Re: **Application for Coastal Development Permit**
ENV-2012-131-MND (revised) dated June 17, 2013 , Case No. ZA-2012-130-CDP
Project at 16990 - 17000 Sunset Blvd., Pacific Palisades, CA 90272

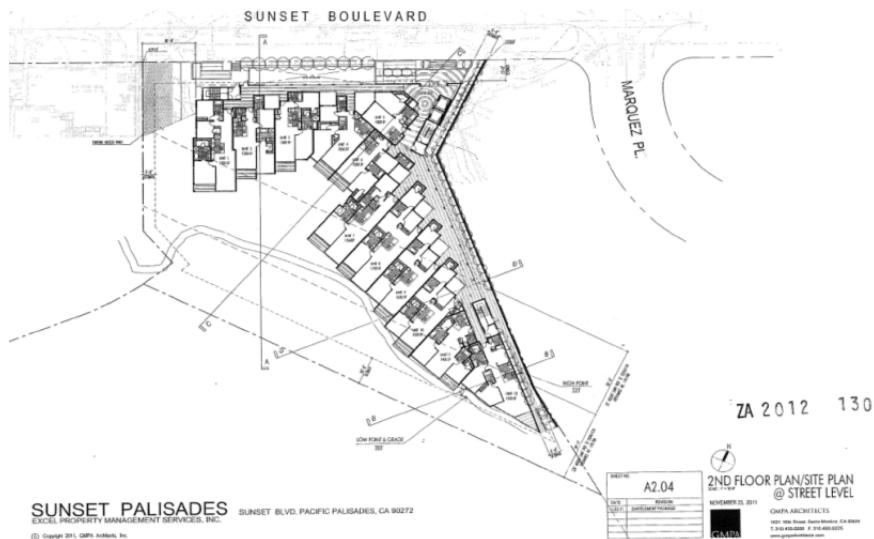
As noted in our prior letter, Sunset Boulevard is a designated Scenic Major Highway, Class II. From atop the bluff, the Project site is one of the two major unobstructed public ocean views from this stretch of Sunset Boulevard until it intersects Pacific Coast Highway, affording motorists and pedestrians a unique view of the Pacific Ocean and Catalina Island. This view will be obliterated by the Project:

Fatality Spurs Bus Route Study on Sunset Blvd. In Pacific Palisades

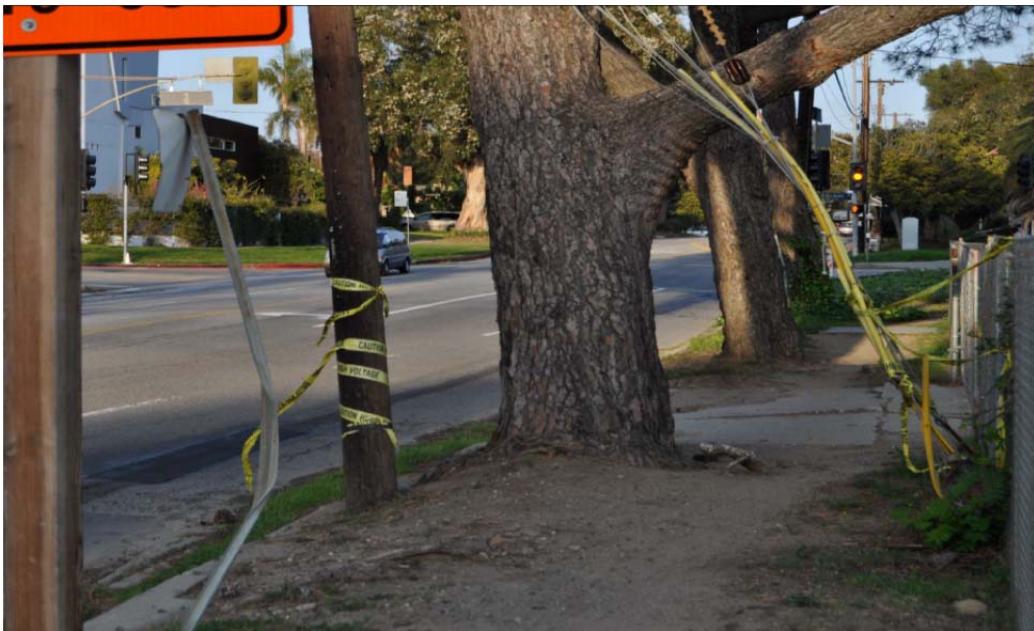
The Project's location at the intersection of Marquez Avenue and Sunset Boulevard is locally known as the entrance and exit of "Dead Man's Curve," long and still the scene of many serious accidents. The long straightaway east of the intersection leads motorists, particularly motorcyclists, to enter the intersection at unusually high speeds at all hours. That was the cause of the most recent fatal accident immediately in front of the Project, in November 2012, involving a motorcyclist traveling at an estimated 80+ miles per hour:

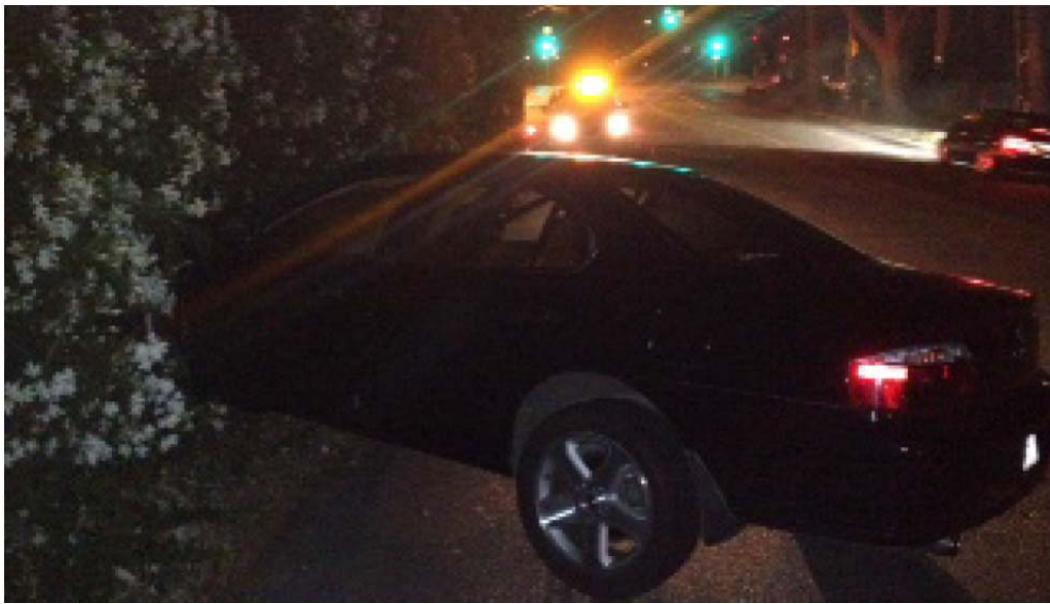
Most recently, on June 13, 2013, this part of Sunset was the scene of a late-night solo spinout accident, in which an eastbound vehicle -- traveling uphill on Sunset -- jumped the curb, ricocheted off the guard rail, crossed all four traffic lanes and came to rest in the shoulder of the westbound lanes across from the driveway of the Project site (the traffic signals here are the same ones pictured in the previous photograph):
